Storyrock Phase 3

**City of Scottsdale
Stormwater Management**

Drainage Review Memorandum

Re: Storyrock - Phase 3
Case number: 5-PP-2016 #5

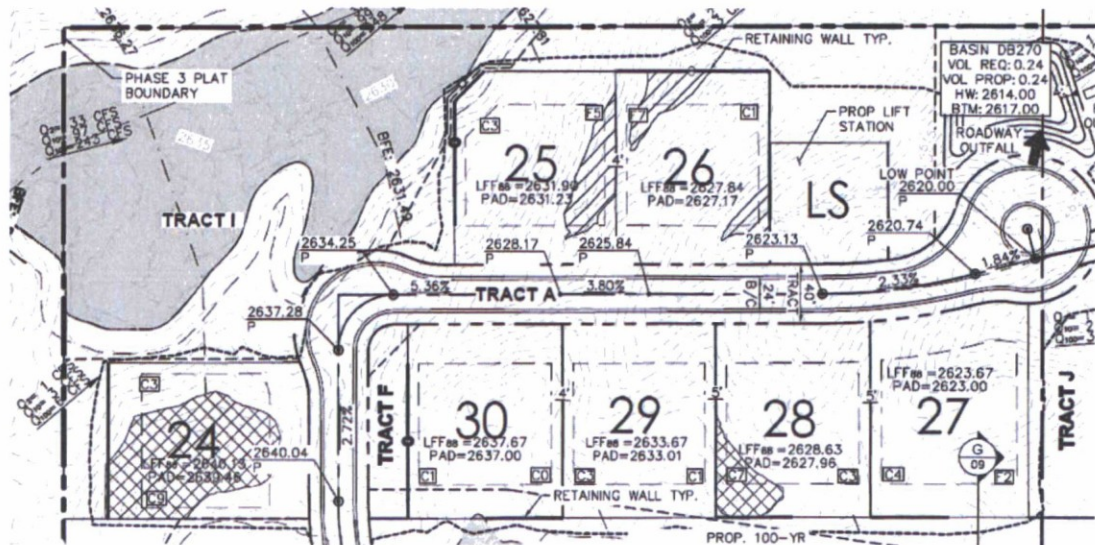
COS 2nd Review: Additional labels are required. Please see grading and drainage plan screen capture below:

KHA 2nd Response: Existing contours have been extensively labeled throughout the preliminary plat with this submittal.

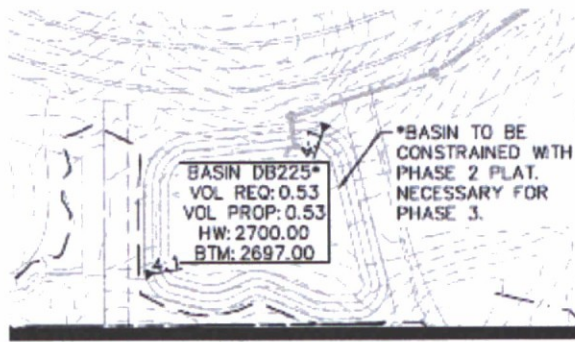
17. **COS 1st Review:** Submit analysis documenting how RTIMP is derived for post development condition HEC-1 model. Add discussion to address LG record value differences between pre and post development conditions. Below you will find a sample basin analysis, which applies to number of basins analyzed with this submittal. Basin ON270 is Zoned Residential R1 18, modeling it with 27% impervious area appears to be low.

COS 2nd Review: Not addressed. Please review and address 1st review comment. Note, Maricopa County Drainage Policies and Standards, Table 6.5 identifies RTIMP of 30% for R1-18 zoning. Based on our experience, full build-out condition in Scottsdale typically results in a higher percent of impervious area when compared to the same zoning in the County.

KHA 2nd Response: As discussed with the City on April 12, a RTIMP comparison exhibit for each zoning category (R1-18, R1-35, and R1-43) has been provided to indicate that the percent impervious RTIMP selected for this project is appropriate and more conservative than calculating a weighted RTIMP for the entire development. The exhibits provided highlight the selected RTIMP for each zoning category versus a representative weighted RTIMP value for the development. The additional exhibits and reference to Maricopa County Drainage Policies and Standards should provide the background required by the City to support the selected RTIMP for the project.
